**LAKE COUNTY
WATER
AUTHORITY
NUTRIENT
REDUCTION
FACILITY**

**SITE
ASSESSMENT**

FINAL

0231754.02
Lake County Water
Authority
April 2021

Figure 1-1: NuRF Capacity (Current)

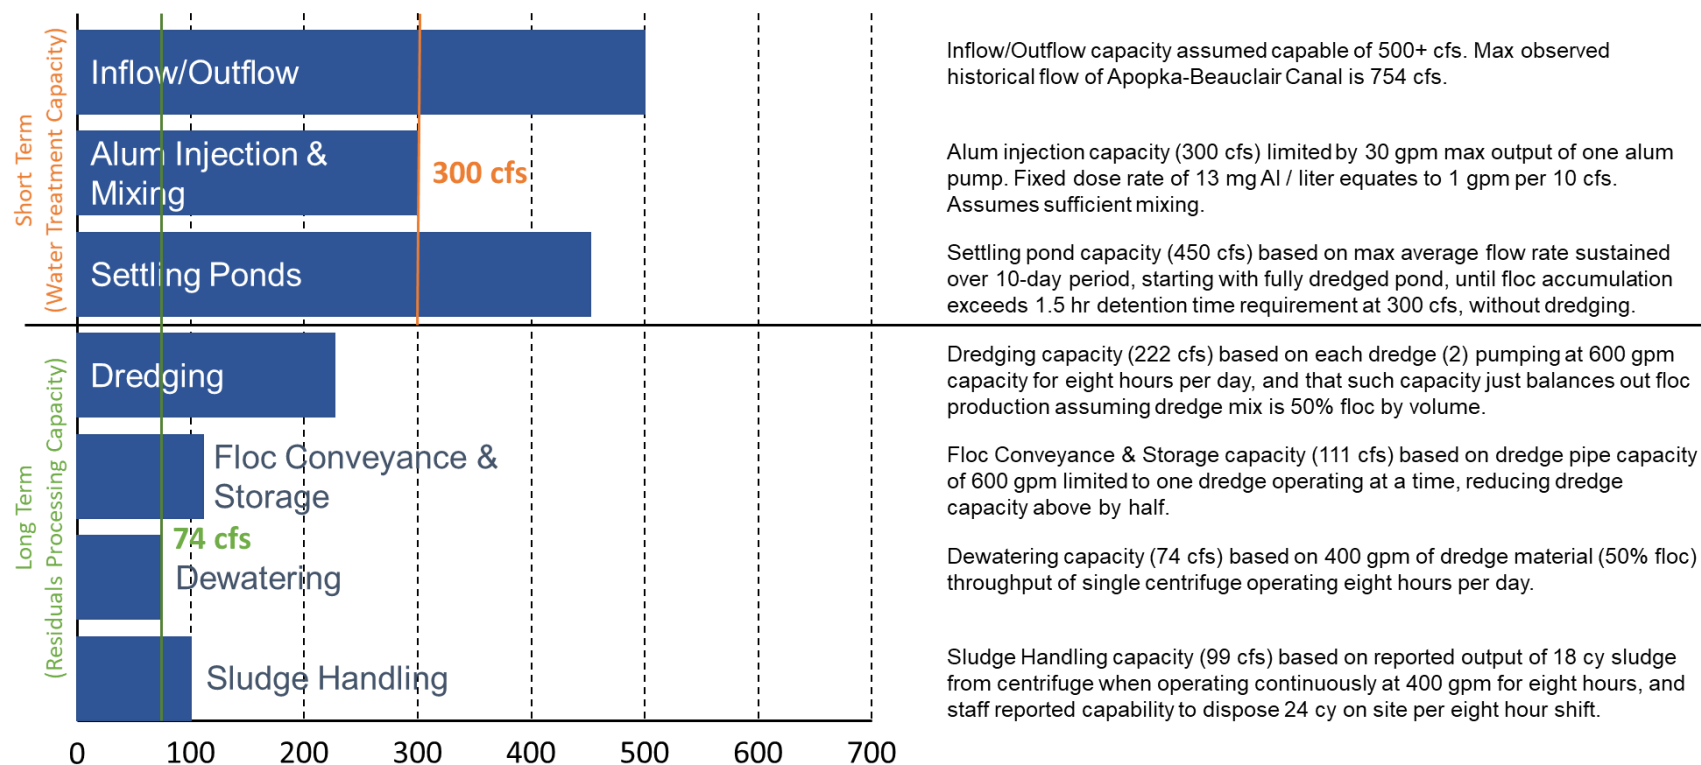
In its present configuration, the dewatering equipment (i.e., centrifuge) limits the long-term sustained capacity of the NuRF to 74 cfs. While this appears well short of the 300 cfs operational goal, it is important to recognize that the processes 4-7 currently require staff to be on site for operation. Therefore, the capacity of these processes depends directly on number of hours per day that the NuRF is staffed. This capacity evaluation is based on the NuRF being staffed for one eight-hour shift per day, which means the capacity of these processes could be effectively doubled by running an additional eight-hour shift during periods where higher flows required it. The less frequently these high flows are encountered, the more cost-effective adding a second shift would be compared to the capital cost of twice as much equipment. The dewatering capacity of the NuRF is discussed in more detail in Sections 6.4 through 6.7.

Inflow/Outflow capacity assumed capable of 500+ cfs. Max observed historical flow of Apopka-Beauclair Canal is 754 cfs.

Alum injection capacity (300 cfs) limited by 30 gpm max output of one alum pump. Fixed dose rate of 13 mg Al / liter equates to 1 gpm per 10 cfs. Assumes sufficient mixing.

Settling pond capacity (450 cfs) based on max average flow rate sustained over 10-day period, starting with fully dredged pond, until floc accumulation exceeds 1.5 hr detention time requirement at 300 cfs, without dredging.

Dredging capacity (222 cfs) based on each dredge (2) pumping at 600 gpm capacity for eight hours per day, and that such capacity just balances out floc production assuming dredge mix is 50% floc by volume.

Floc Conveyance & Storage capacity (111 cfs) based on dredge pipe capacity of 600 gpm limited to one dredge operating at a time, reducing dredge capacity above by half.

Dewatering capacity (74 cfs) based on 400 gpm of dredge material (50% floc) throughput of single centrifuge operating eight hours per day.

Sludge Handling capacity (99 cfs) based on reported output of 18 cy sludge from centrifuge when operating continuously at 400 gpm for eight hours, and staff reported capability to dispose 24 cy on site per eight hour shift.
